## Accessibility Audit Report

# Ringsend to City Centre Core Bus Corridor Scheme

## Accessibility Audit Report

Project Title: <b>BUSCONNECTS INFRASTRUCTURE DUBLIN</b>			
Drawing Title: <b>ROUTE 16: RINGSEND TO CITY CENTRE ACCESSIBILITY AUDIT</b>			
Drawing File Name: BCIDD-ROT-PMG_PS-0016_XX_00-AU-CR-0004	Sheet Number: 04 of 10	Status: SO	Rev: K01

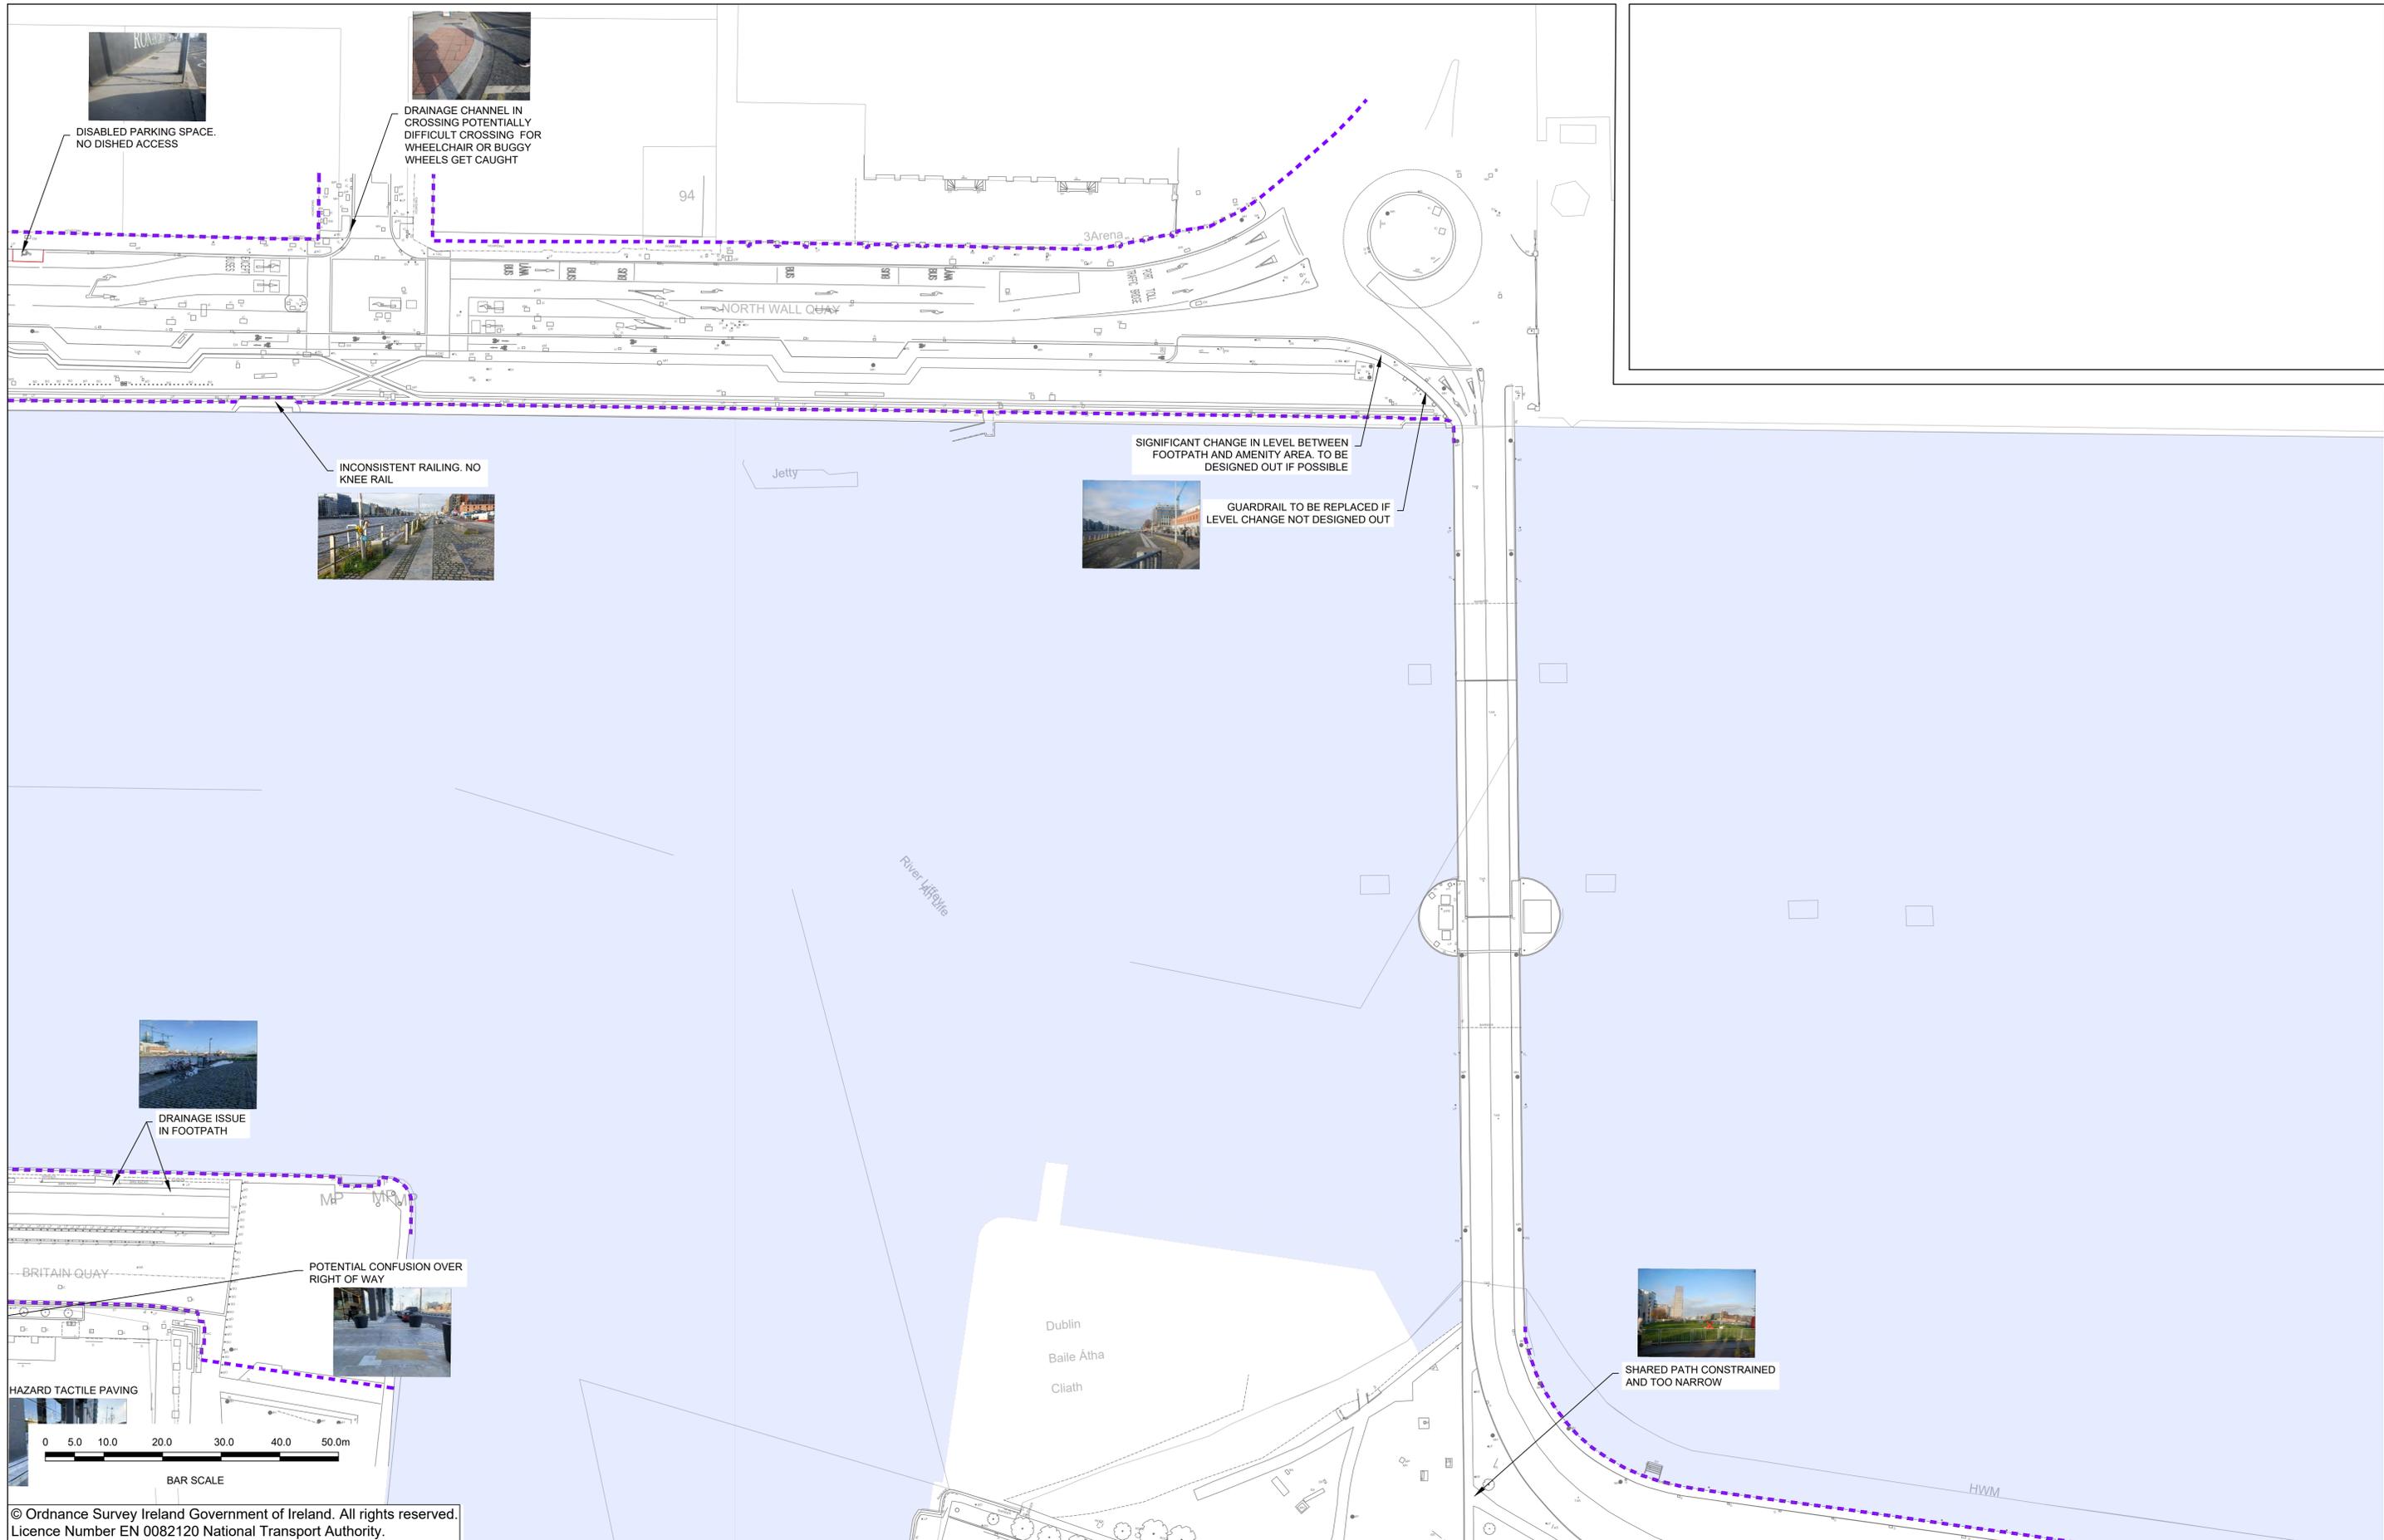
BCIDD-ROT-PMG_PS-0016_XX_00-AU-CR-0004	On a minor access street was noted on the south quays where pedestrians have not been given crossing priority over it. This is reinforced through the presence of tactile paving despite the continuation of pavement materials. It is recommended that priority be given to pedestrians across all accesses to reduce the level of uncertainty over priority on what appears to be footpath	Yes	Yes	Footpath and crossing updated
BCIDD-ROT-PMG_PS-0016_XX_00-AU-CR-0005	Significant change in level between footpath and amenity area. To be designed out if possible	Yes	Yes	Done
BCIDD-ROT-PMG_PS-0016_XX_00-AU-CR-0005	Guardrail to be replaced if level change no designed out	N/A	N/A	Outside of scope of Proposed Scheme
BCIDD-ROT-PMG_PS-0016_XX_00-AU-CR-0006	The shared space is insufficient for the volumes of both pedestrians and cyclists that are forced to interact with each other.	Yes	Yes	Junction updated

Project Title			
BUSCONNECTS INFRASTRUCTURE DUBLIN			
Drawing Title			
ROUTE 16: RINGSEND TO CITY CENTRE ACCESSIBILITY AUDIT			
Drawing File Name	Sheet Number	Status	Rev
BCIDD-ROT-PMG_PS-0016_XX_00-AU-CR-0007	07 of 10	SO	K01

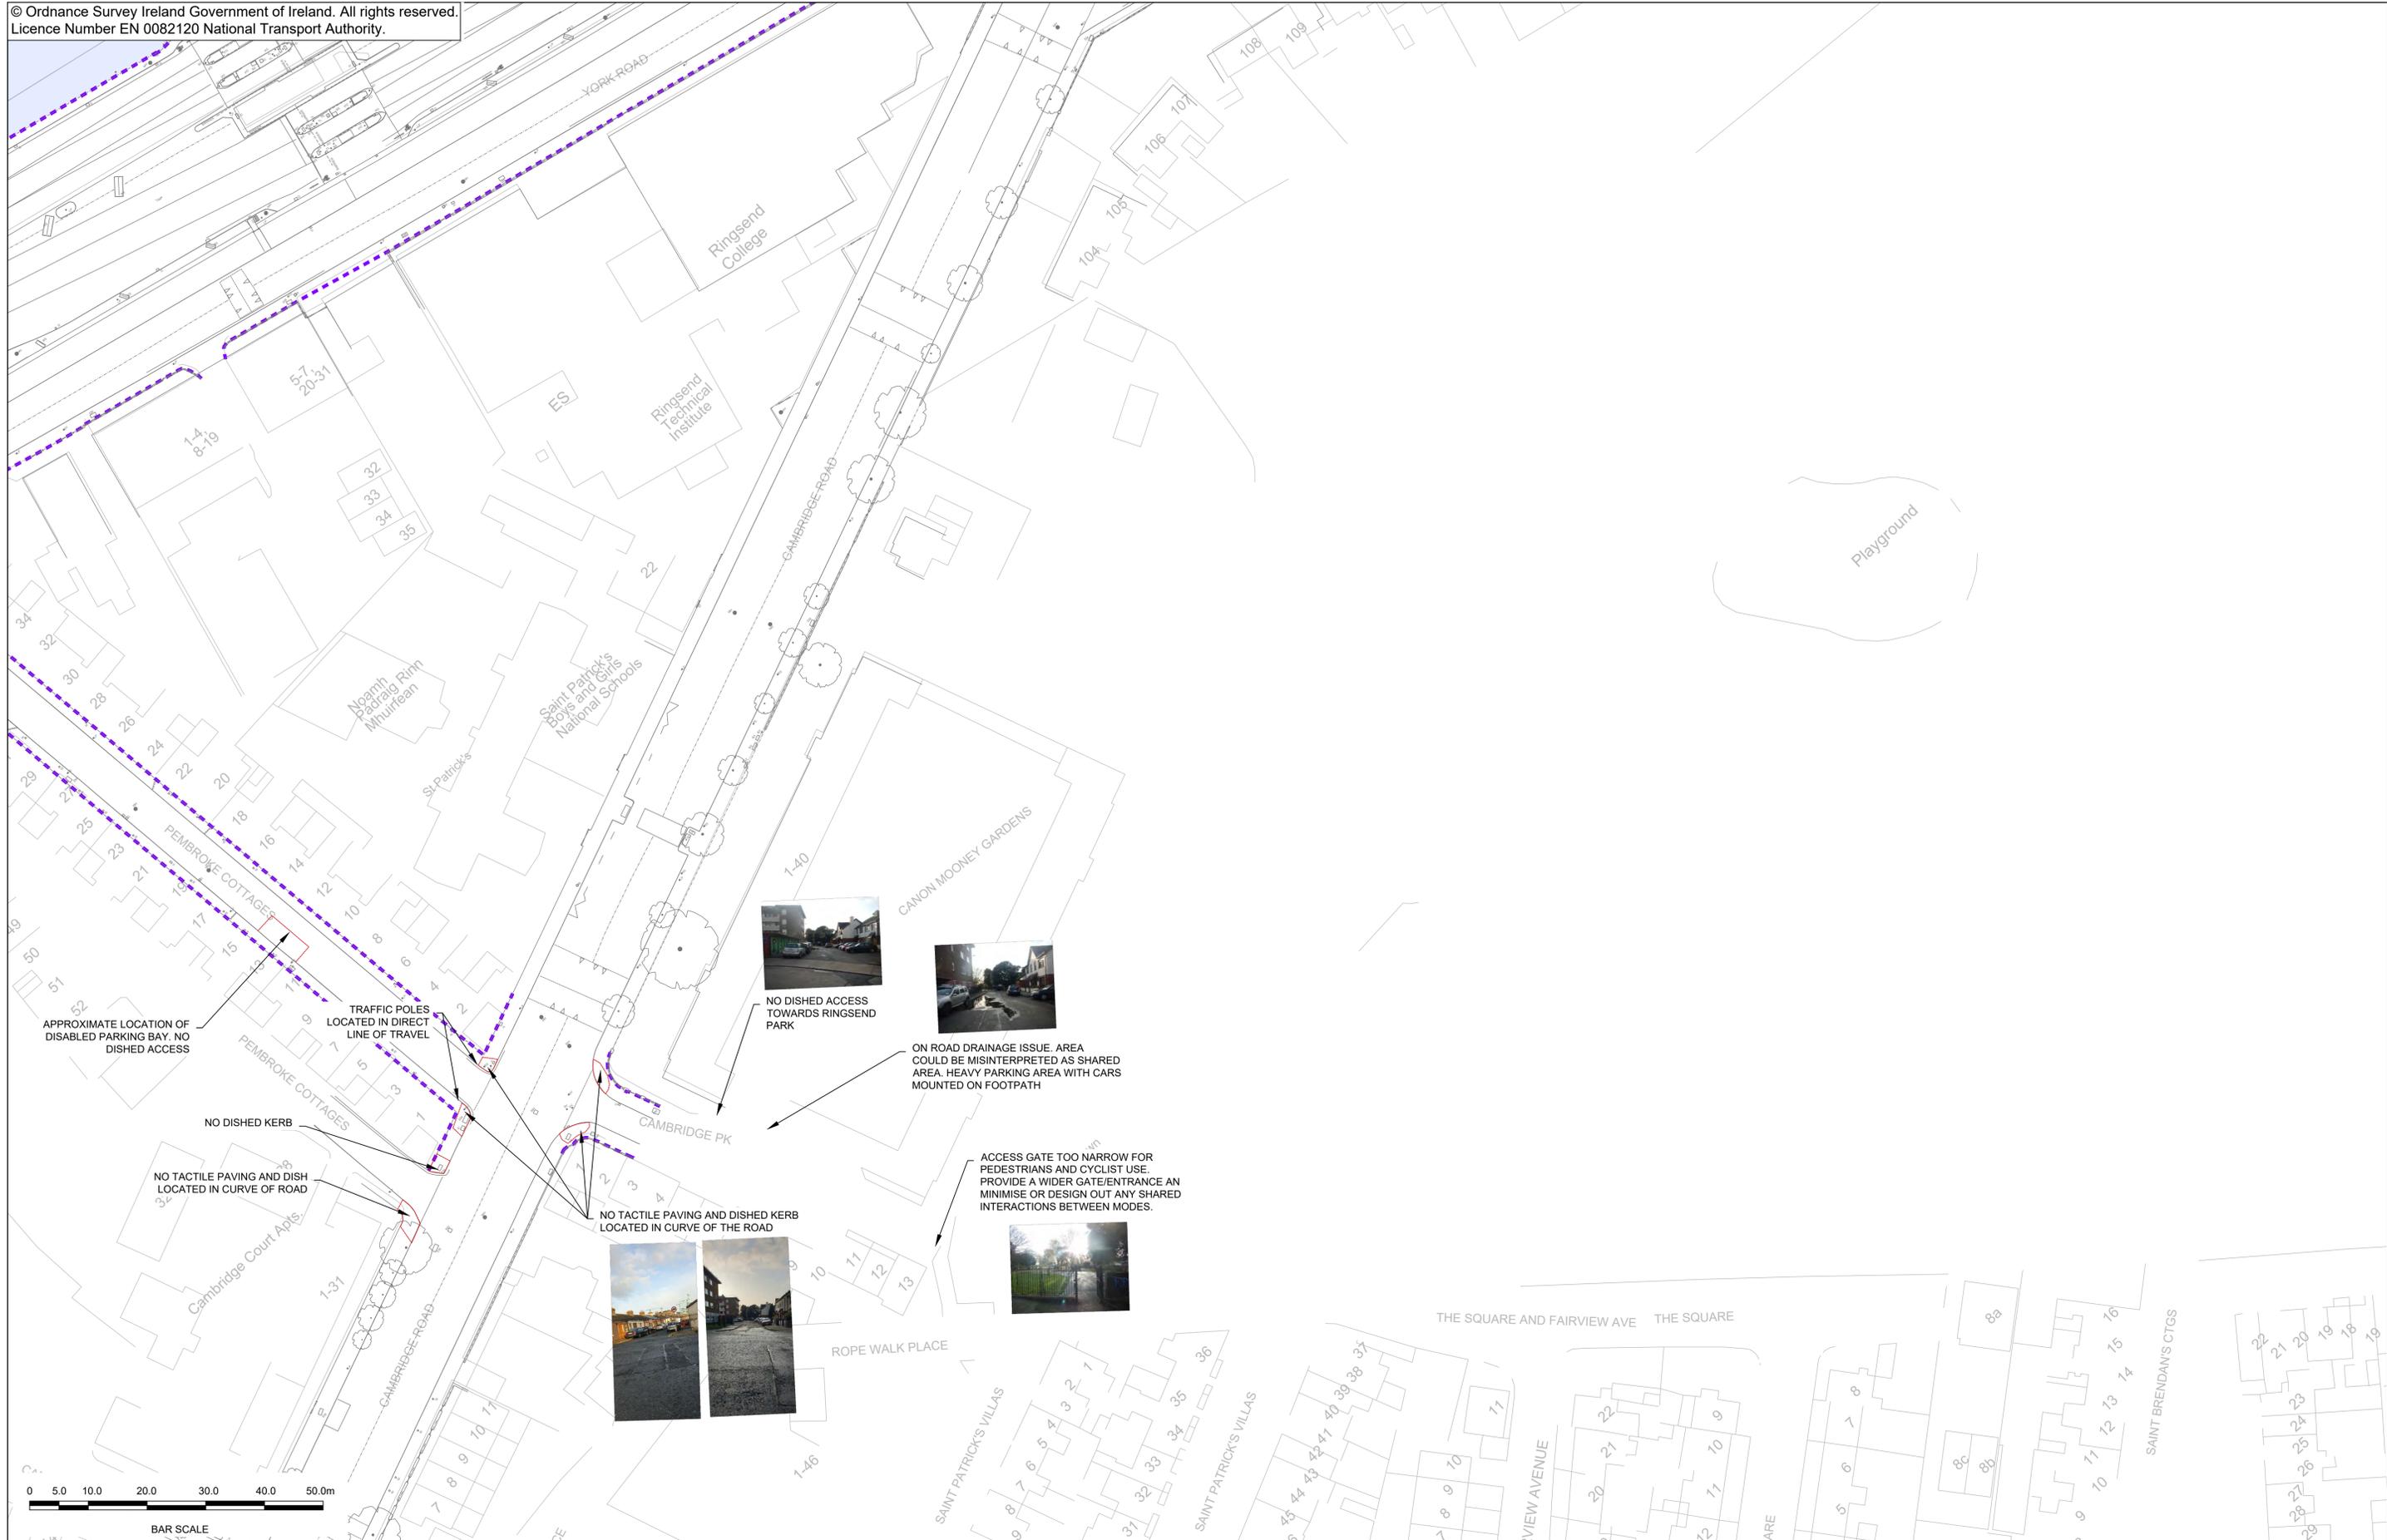
BCIDD-ROT-PMG_PS-0016_XX_00-AU-CR-0007	Guardrail present due to pedestrian link and traffic calming ramp located in line. Move ramp in design or replace guardrail	Yes	Yes	This will be reviewed during Detailed Design
BCIDD-ROT-PMG_PS-0016_XX_00-AU-CR-0007	There is no dish access to the footpath from parking space. This would make it difficult for the disable user to transfer safely between the footpath and the car without an aid, and also prevents access to the rear of the car using a ramp or tail lift.	Yes	Yes	Kerbs types will be reviewed during Detailed Design
BCIDD-ROT-PMG_PS-0016_XX_00-AU-CR-0008	Guardrail present due to pedestrian link and traffic calming ramp located in line. Move ramp in design or replace guardrail	Yes	Yes	This will be reviewed during Detailed Design
BCIDD-ROT-PMG_PS-0016_XX_00-AU-CR-0009	There is no dish access to the footpath from parking space. This would make it difficult for the disable user to transfer safely between the footpath and the car without an aid, and also prevents access to the rear of the car using a ramp or tail lift.	Yes	Yes	Kerbs types will be reviewed during Detailed Design
